UNITED STATES PATENT AND TRADEMARK OFFICE

10/664,371

Office Action Summary	Application No. 10/664,371	Applicant(s) ORBAY, JORGE L.	
	Examiner Anu Ramana	Art Unit 3775

DETAILED ACTION***Claim Rejections - 35 USC § 102***

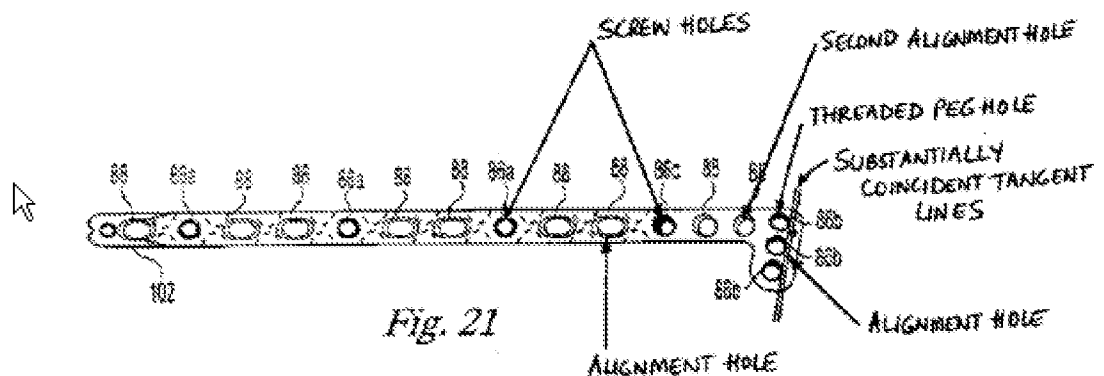
Claims 37-38, 45-48, 51 and 53-55 are rejected under 35 U.S.C. 102(e) as being anticipated by Weaver et al. (US 6,623,486).

Weaver et al. disclose a bone fixation plate 80 including: a head angled relative to a the shaft; the head portion defining a first set of threaded holes 86b; alignment holes much smaller in diameter than the threaded holes for provisional fixation of the bone plate; a second alignment hole 88; and a plurality of screw holes 86a in the shaft of the bone plate (Figs. 20-26, col. 6, lines 58-67 and col. 7, lines 1-17). See marked up Fig. 21 from Weaver et al. on the following page.

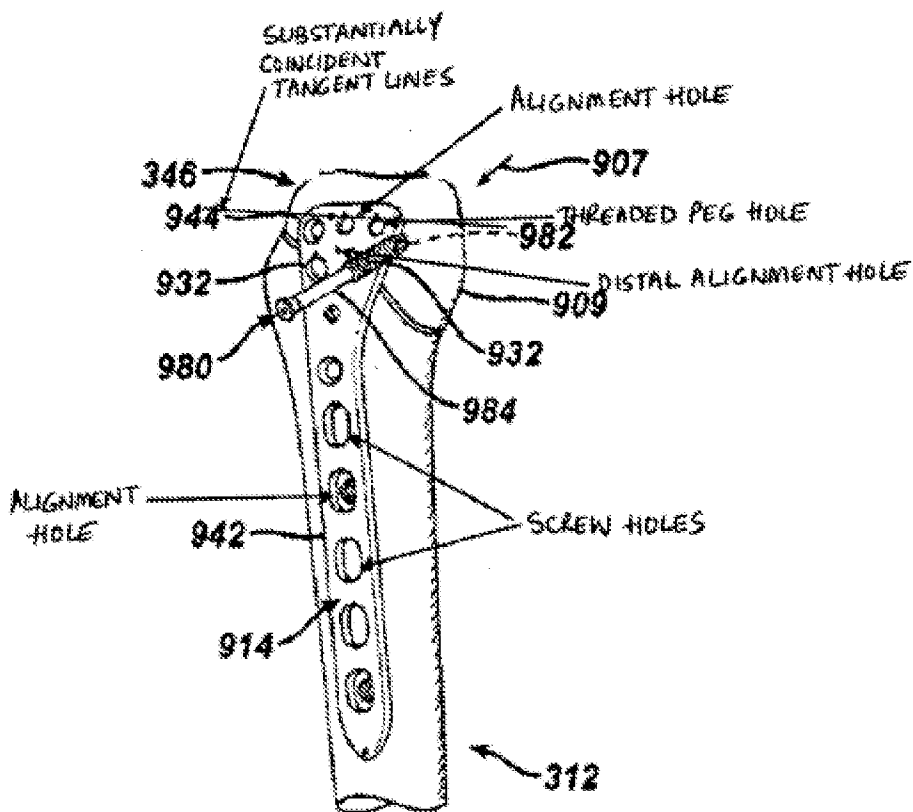
Claims 37-38, 40-43, 45-46, 48-51, 53-55, 58-59 and 65-69 are rejected under 35 U.S.C. 102(e) as being anticipated by Wack et al. (US 2004/0030339 A1).

Wack et al. disclose a plate 914 defining a first set of peg holes structurally adapted to engage a threaded head of a fixation peg and at least one non-threaded alignment hole 871 having a second relatively small diameter wherein the first alignment hole defines a tangent line substantially coincident with a line tangent to the first set of threaded (Figs. 20-22 and paras [0118]-[0162]). See a portion of Fig. 20 marked up to show features of Applicant's invention below.
